General Bid Bulletin No. 5
October 26, 2017

Invitation for Bid No. 17-065-3

***Expansion of the Existing Depot at Baclaran and
Construction of a New Satellite Depot at Zapote for
Light Rail Transit (LRT) Line 1-South (Cavite) Extension Project***

PROJECT: MANILA LRT1 CAVITE EXTENSION (L1CEP)	DRAWING NO: L1CEP1-EPC-D2-POS-LAY-0016
TITLE: BACLARAN DEPOT - TPS EQUIPMENT LAYOUT	
	A

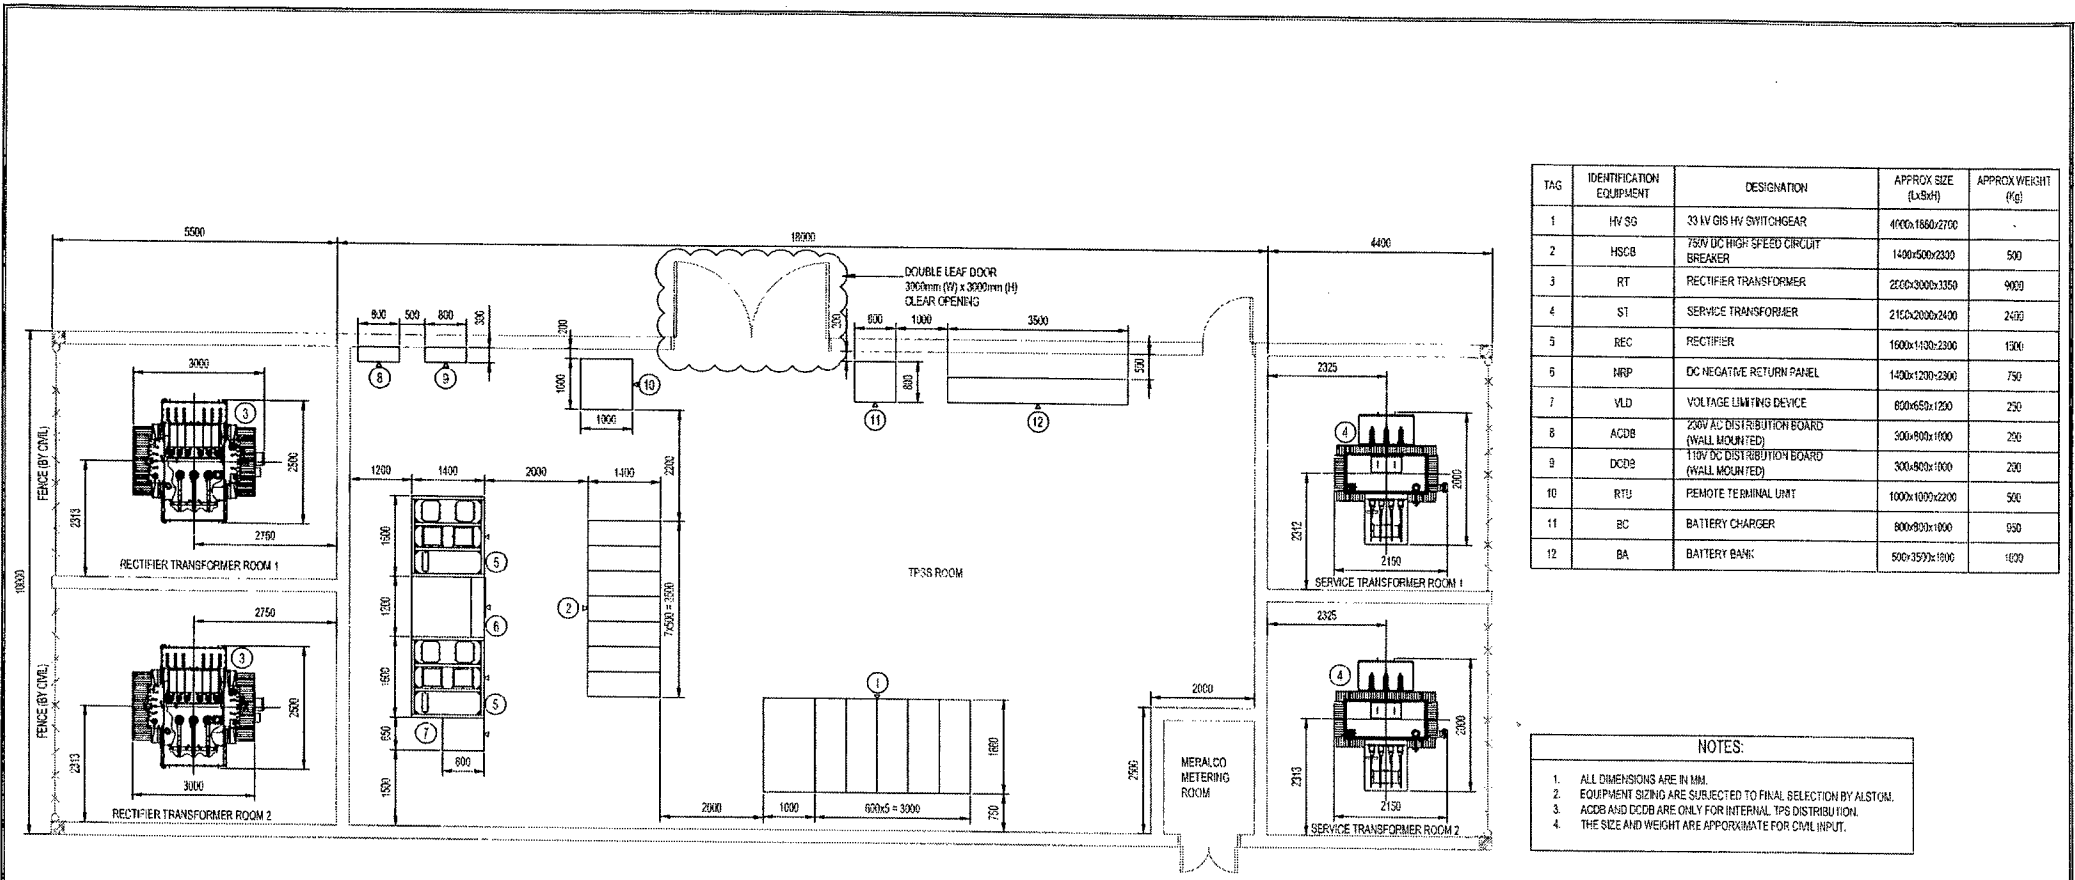
<p>Thus, in relation to General Bid Bulletin No. 16, supply and termination of MV cables connecting the MV switchgear & transformer is not included in the contractor's scope of work.</p> <p>Please confirm.</p>	<p>and termination of cables connecting from the output of EPC switchgear/transformer is included in the Contractor's Scope.</p>
19	VI-2	Technical Requirements / Technical Specification/D. Building E&M Work	<p>"Note: The following works are excluded from E&M Building services... a) HV/MV Supply Power;"</p> <p>Please provide details on the substation for the following for structural design consideration and cabling route:</p> <ul style="list-style-type: none"> a. HV/MV equipment layout on the substation (switchgear, transformers, etc.) b. Equipment loading 	<ul style="list-style-type: none"> a. HV/MV equipment layout on the substation (switchgear, transformers, etc.) is attached for reference. b. Equipment Loading for the Baclaran Depot Sub-station is shown on the attached drawings. For Zapote Depot Sub-station, the equipment loading is not yet available.
